ZU1 SYSTEM BLOCK DIAGRAM

PROJECT : ZU1

Quanta Computer Inc.

Size	Document Number	Rev
	GMCH HOST(1 of 7)	3B
Date:	Tuesday, April 10, 2007	Sheet 5 of 39

**PROJECT : ZU1**
Quanta Computer Inc.
SYSTEM 5V/3V (ISL6236)

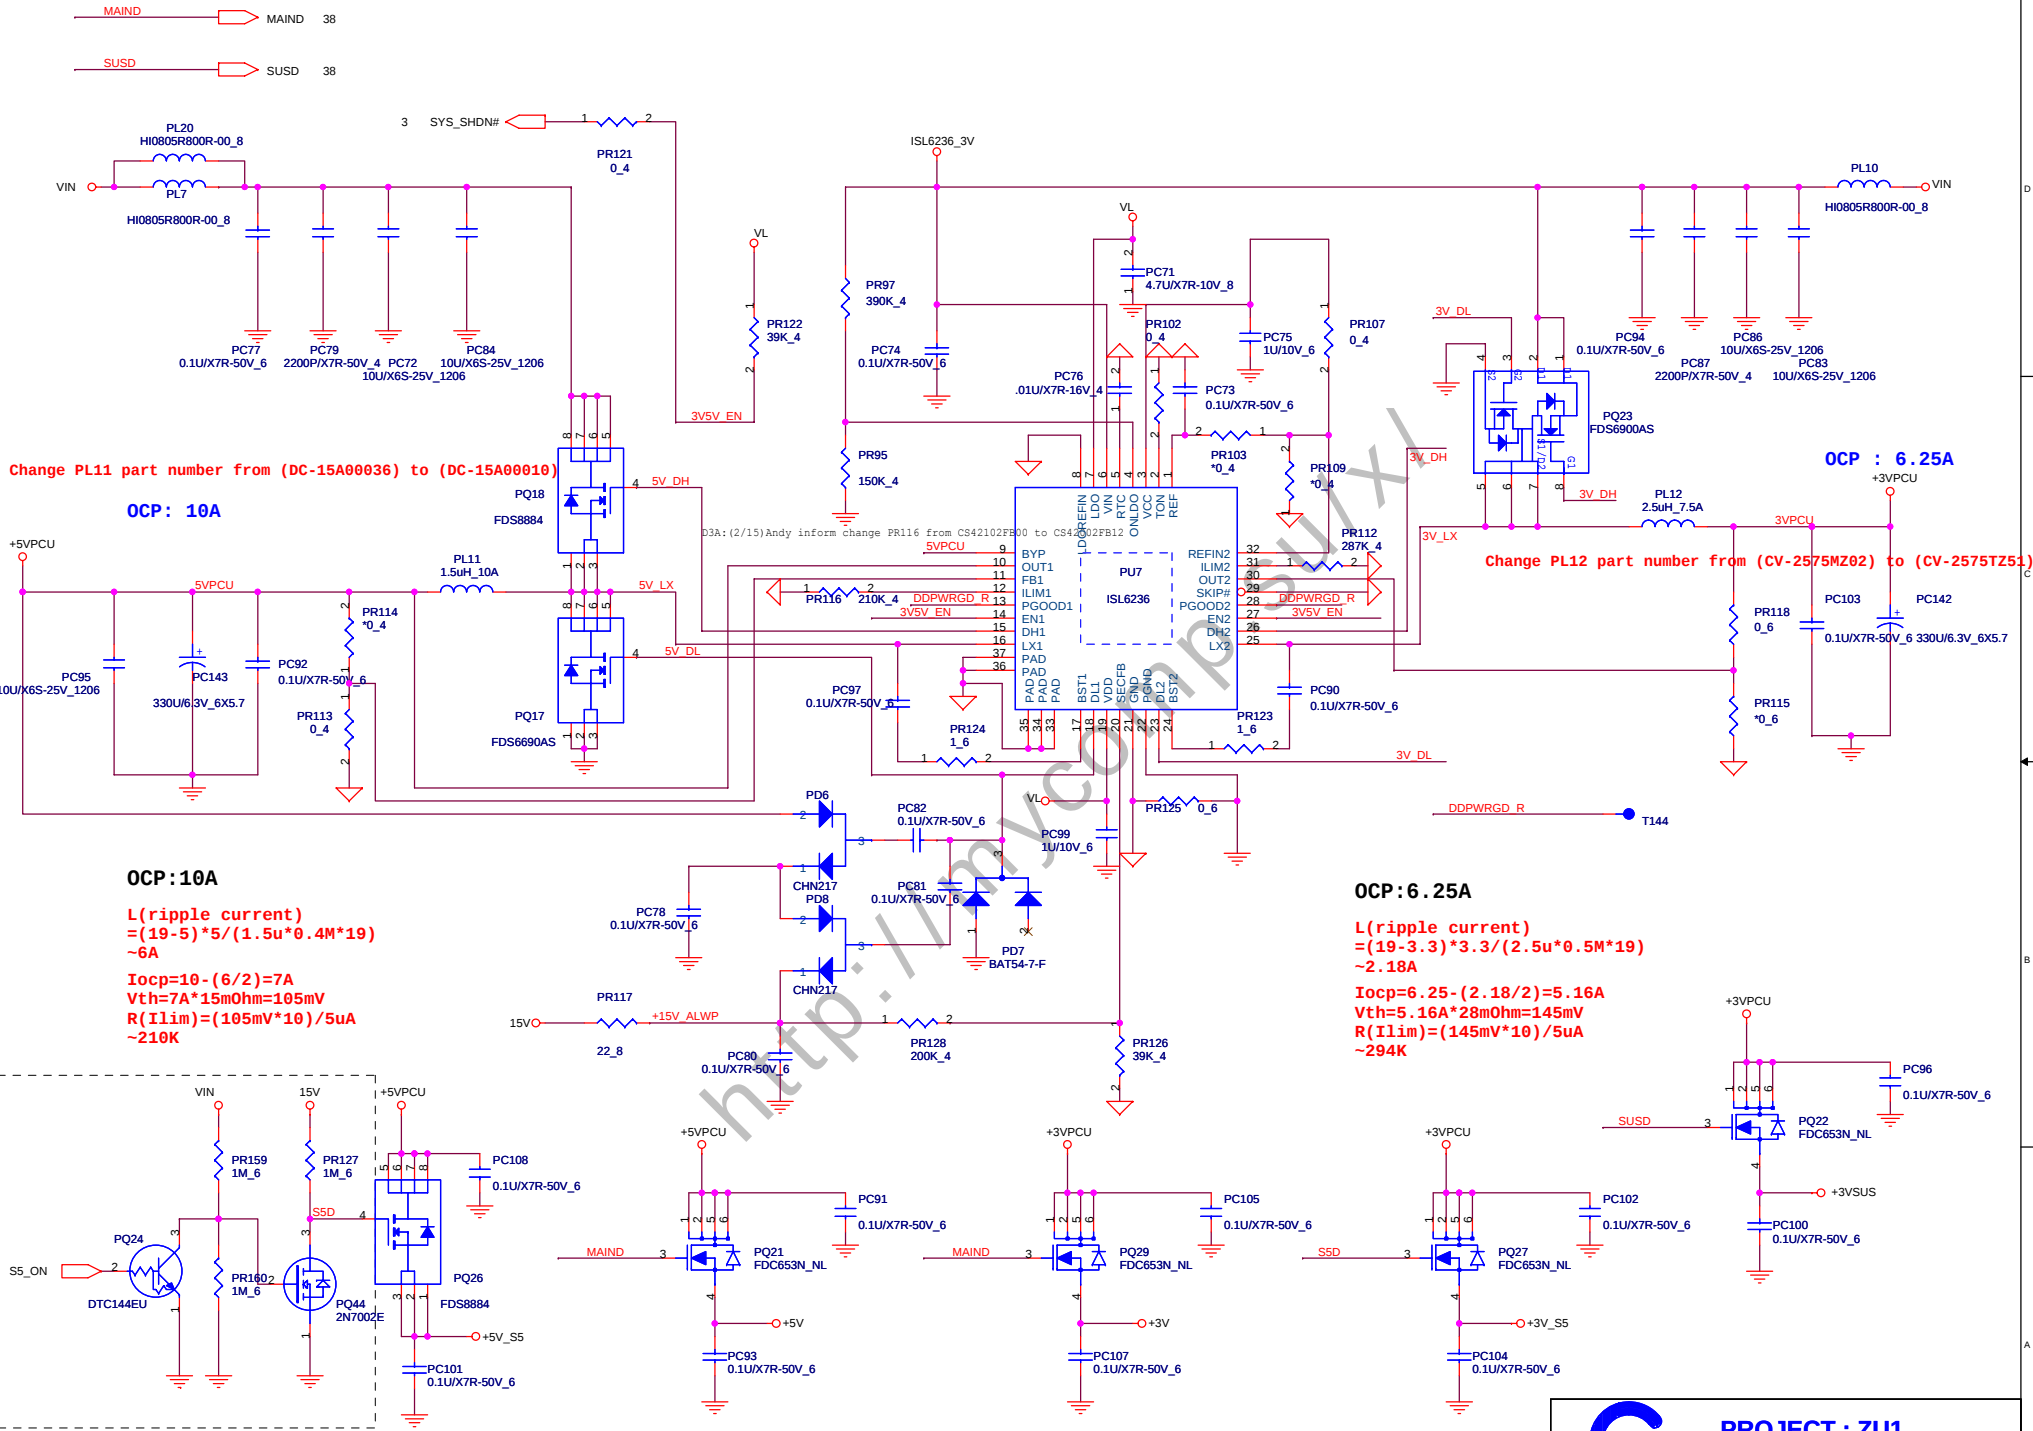
Change PL11 part number from (DC-15A00036) to (DC-15A00010)

C2A: (12/10) change S5_ON control circuit

B1C: (11/29) change PQ26 from FDS6690AS (BAM6690022) to FDS8884 (BAM8884006)
